Re: Chevron Service Station # 9-0917

Address: 5280 Hopyard Road, Pleasanton, California

Re: **Response to Comments**  
Chevron Service Station 9-0917  
5280 Hopyard Road, Pleasanton, California  
Fuel Leak Case No. RO0000439

Figure: 1 – Site Plan with Dissolved and Residual Hydrocarbon Impact

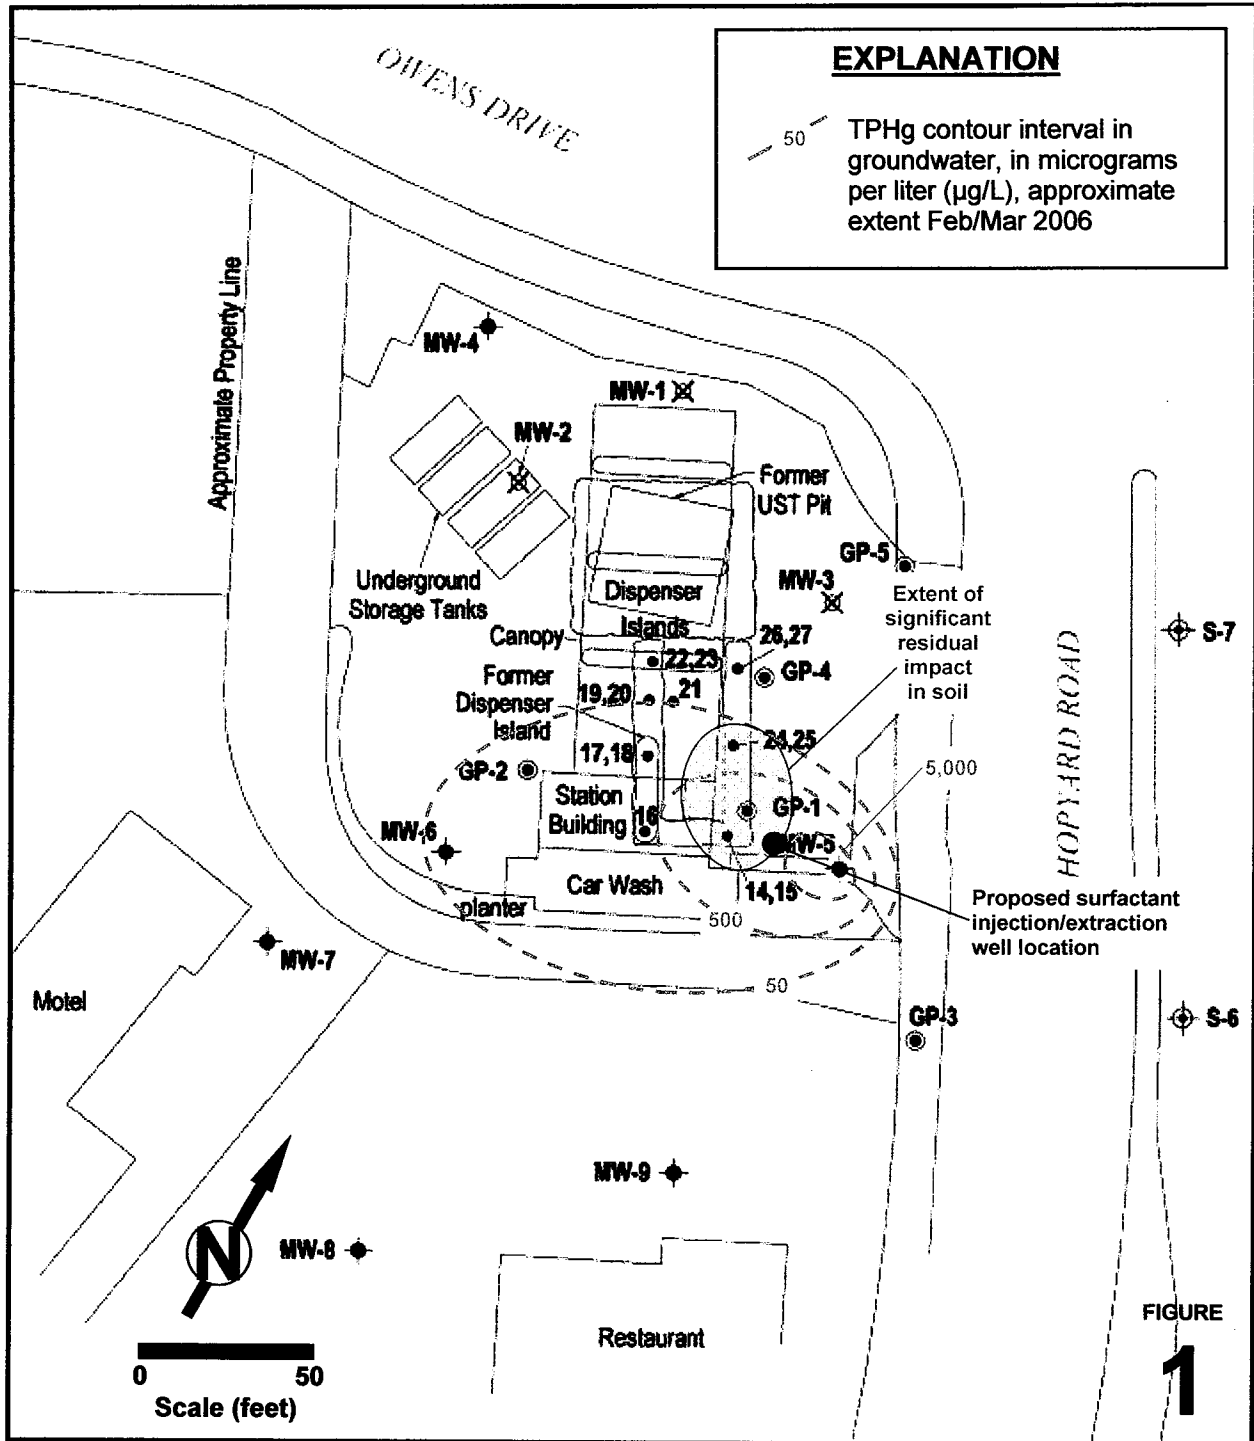
**1) Will the proposed remedial action be expanded to treat the source area, and is it feasible to treat the source area with the proposed technology given the current site configuration?**

**2) Discuss how the radius of influence will be determined around well MW-5, or whether an additional monitoring or extraction well will be needed to conduct the pilot test.**

1. **Scope of Pilot Test.** Surfactant is to be applied at a rate that will reach a radius of approximately 10 feet from the well prior to vacuum-enhanced recovery. Well MW-5 is located approximately 25 to more than 100 feet from the sampling locations where elevated concentrations of petroleum hydrocarbons were detected in soil during the 1991 UST, dispenser, and piping replacement. Therefore, the pilot test will only treat soil and groundwater within a limited radius of well MW-5 and will not treat soil and groundwater within most of the source area. Although we do not object to the use of surfactant enhanced extraction in a pilot test, please describe in the requested Response to Comments whether the pilot test would be expanded to treat the remainder of the source area and the feasibility of treating the source area given the current configuration of the service station.

2. **Monitoring Performance of Pilot Test.** Performance during the pilot test will be estimated using groundwater concentrations in samples collected monthly from injection/extraction well MW-5. Therefore, the distance away from the well over which the treatment is effective will not be known. Please describe in the Response to Comments requested below, how monthly concentrations in well MW-5 can be used to estimate the distance from the well that the surfactant treatment is effective or propose an additional monitoring or extraction well to conduct the pilot test.

Cambria will expand the proposed remedial action as warranted by the results of the pilot test to treat the source area as described below. As shown on Figure 1 and discussed below, the majority of residual hydrocarbon impact appears to be limited in extent near the north-northeast corner and northeast side of the existing station building, and implementation of the proposed surfactant remedial alternative should be feasible for a majority of this area.

In order to better evaluate the radius of remedial influence, and target more known residual impact in soil, Cambria will install a surfactant injection/extraction well for the pilot test at the location shown on Figure 1, near boring GP-1. This location places the remedial well within the area identified as having the majority of residual impact in soil at the site—in the area of the former easternmost product lines. Although the highest residual hydrocarbon concentration in

Cambria proposes the following scope of work to install one injection/extraction well at the location shown on Figure 1.
